No. 97-20

Official Notification Under The U.S. Federal Boat Safety Act

EFI and MPI Fuel Line Replacement

1. MCM 4.3L EFI, 5.0L EFI, 5.7L EFI (TBI) Sterndrive Engines:

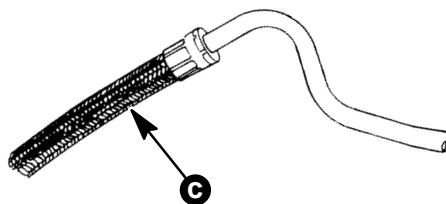
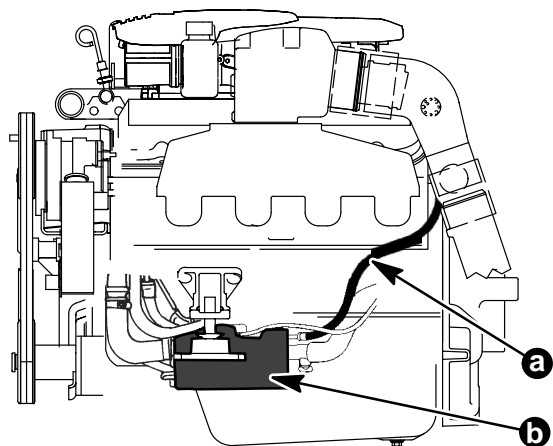
Look at the fuel cooler to TBI fuel line. If it is braided, the fuel line IS GOOD and does not have to be replaced.

Change incorrect fuel lines on any engine that you have in stock. If the boat has been sold, please contact your customer and perform this service on their engine(s).

2. 1997 MCM 7.4LX MPI, 454 Mag MPI, 502 Mag MPI Sterndrive Engines:

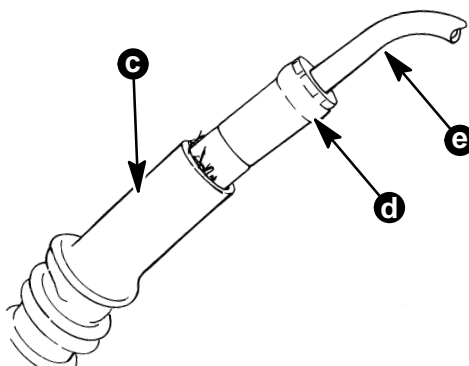
Look at the fuel cooler to fuel rail line. If the fuel line has a 'fire sleeve' AND the metal hose coupler is brass, the fuel line IS GOOD and does not have to be replaced.

3. 1997 MCM 350 Mag MPI Sterndrive Engines:
 1997 MIE Black Scorpion MPI Ski, 377 Scorpion MPI Ski Engines:
 1998 MCM 350 Mag MPI Sterndrive Engines:
 1998 MIE 350 Mag MPI Ski Engines:
 1998 MIE 350 Mag MPI Inboard Engines:

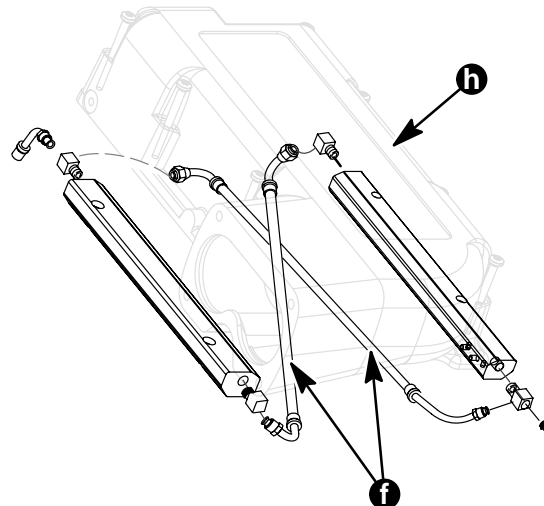
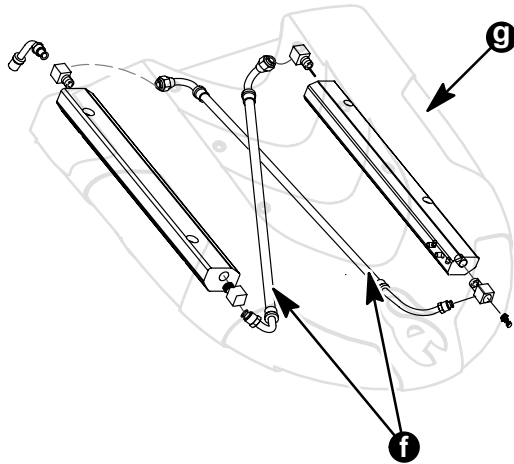
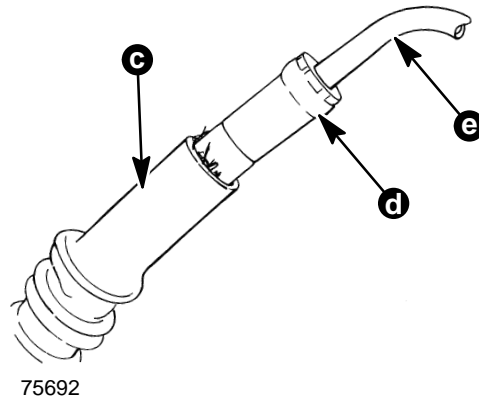
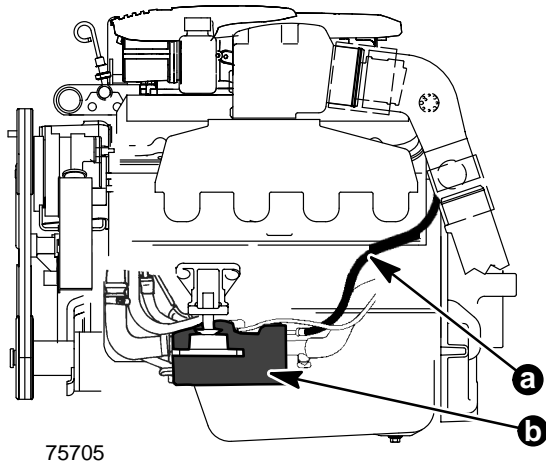
- a. Look at the fuel cooler to fuel rail line. If the fuel line has a 'fire sleeve' AND the metal hose coupler is brass, the fuel line IS GOOD and does not have to be replaced.
- b. Also look at the 2 rail to rail fuel lines. If the fuel lines have a 'fire sleeve' AND the metal hose couplers are brass, the fuel lines ARE GOOD and do not have to be replaced.
